Access Compliance Report

Public Rights-of-Way

(Pedestrian Signals)

Intersection ID: N/A	Main Street:	Cross Street: N/A	Location: N/A
ADA ID: AEB47738E6A4	Signal Type: One Push Button-APS	Overall Compliance: No	Severity Score: BTN 1: N/A BTN 2: N/A No BTN: N/A
Codes/Mitigation Info/Possible Solution		Field Measurements/Component Compliance

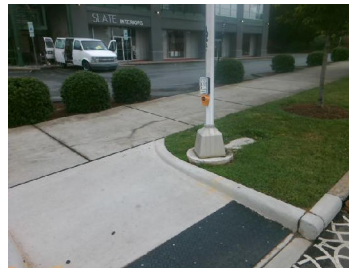
Surveyor Notes: TEXT HT 3/8

PROW/ADA: R410.6, R404.2, R404.3, R406.2,
R404.7.3, R209.1, MUTCD 4e.10

Possible Solutions: Remove & Replace
Replace APS Button With New APS Button.
Remove and Replace Clear Space.
